# Access Compliance Report

## Public Rights-of-Way

### (Curb Ramps)

Intersection ID: 2698	Main Street: GRABURN'S_FORD_DR	Cross Street: HIGHLAND_CREEK_PY	Location: SE
ADA ID: EE7C18DBA42D	Ramp Type: Perp	Initial Pass/Fail: Fail	Overall Compliance: No
Severity Score: 55			
Codes/Mitigation Info/Possible Solution		Field Measurements/Component Compliance

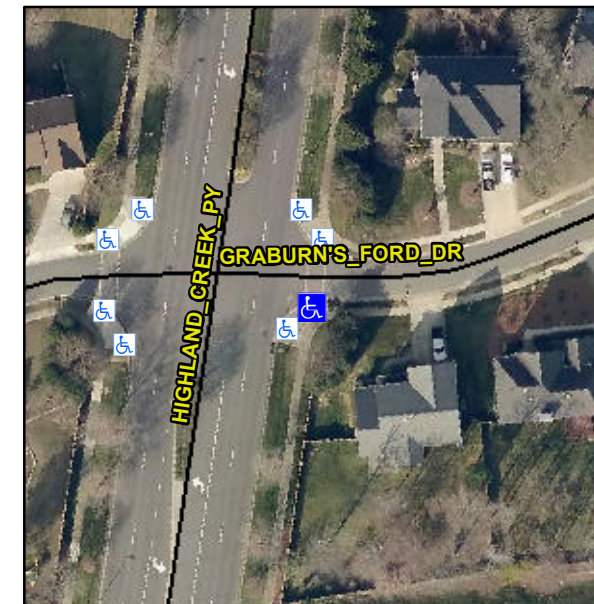
**R304.5.1, R304.2.2, R304.5.3**

Compliance	Description	Data	Compliance	Description	Data
N/A	Ramp Length (in)	82.0	No	Ramp Slope (%)	17.2
No	Ramp Width (in)	34.0	No	Ramp XSlope (%)	6.0
N/A	Flare Type LT	N/A	N/A	Flare Type RT	N/A
N/A	Flare Slope LT (%)	N/A	N/A	Flare Slope RT (%)	N/A
N/A	Flare Traversable LT?	N/A	N/A	Flare Traversable RT?	N/A
N/A	Landing Length (in)	N/A	N/A	DWS Provided?	N/A
N/A	Landing Width (in)	N/A	N/A	DWS Contrast?	N/A
N/A	Landing Slope (%)	N/A	N/A	DWS Length (in)	N/A
N/A	Landing X Slope (%)	N/A	N/A	DWS Full Width?	N/A
N/A	Landing Curb? (Y/N)	N/A	N/A	DWS Offset (in)	N/A
N/A	Shared Landing?	N/A			
N/A	Gutter Ponding?	N/A	N/A	Gutter Slope (%)	N/A
N/A	Gutter Lip Ht (in)	N/A	N/A	Gutter X Slope (%)	N/A
N/A	Painted X Walk1?	Yes	N/A	Painted X Walk2?	N/A
	X Walk 1 Direction	To N		X Walk 2 Direction	N/A
N/A	X Walk 1 Width (in)	96.0	N/A	X Walk 2 Width (in)	N/A
	X Walk 1 Slope (%)	0.2		X Walk 2 Slope (%)	N/A
	X Walk 1 X Slope (%)	0.6		X Walk 2 X Slope (%)	N/A

**Remove & Replace Entire Ramp.**
